# CITY OF ALBUQUERQUE

April 23, 2009

**Re: North I-25 Corporate Center Conceptual Grading and Drainage Plan  
Engineer's Stamp not provided, (B18/D01C)**

# PRELIMINARY GRADING PLAN

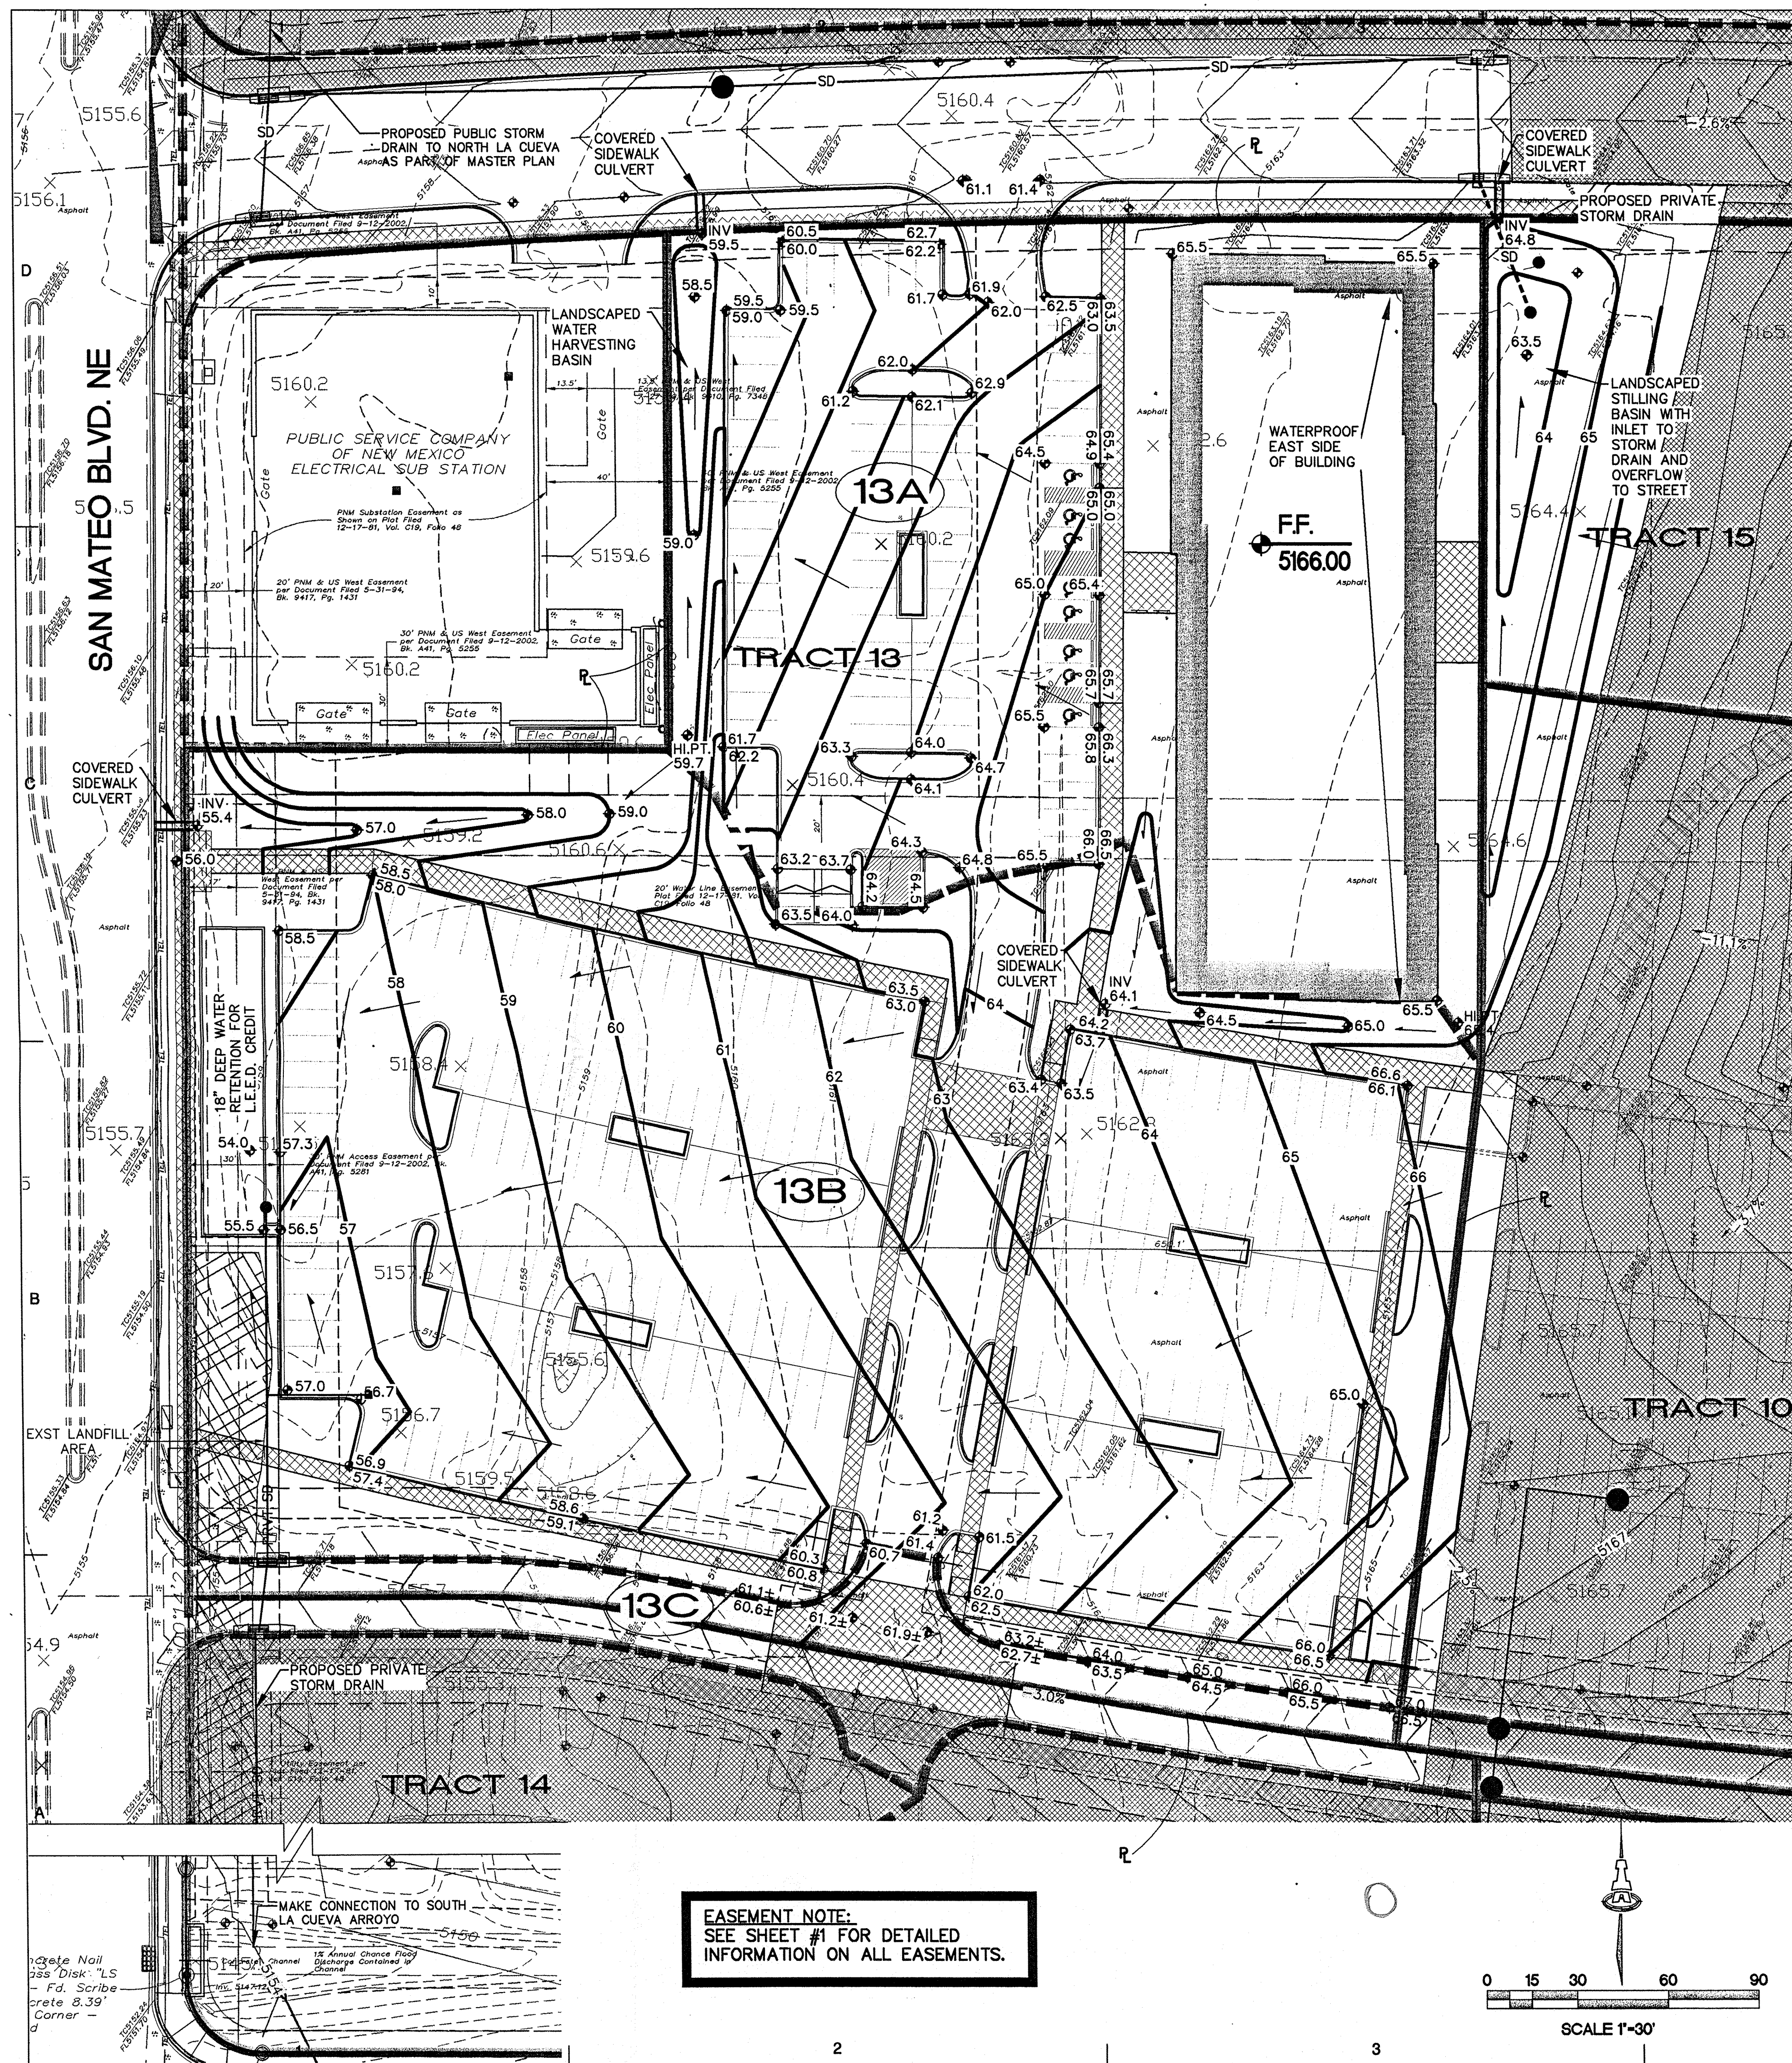
- Please provide a basin delineation map. It is likely that it will be altered as development plans are firmed up for each phase but I need something to start from.
- Please provide pipe sizes based on the above basins. Provide enough design to determine available capacity, necessary inverts, conflicts with other existing and proposed utilities, etc. Why is the storm drain in the northwest corner proposed to be public?
- What offsite (existing and future proposed) runoff enters the site? Please provide appropriate excerpts from any existing reports (both runoff tables and upstream basin maps) to support your proposal.
- Please show proposed lot lines and easements (public and private) and dimension.
- This report should be stamped, signed and dated. Keep in mind that this will be the blueprint for all development within this property.
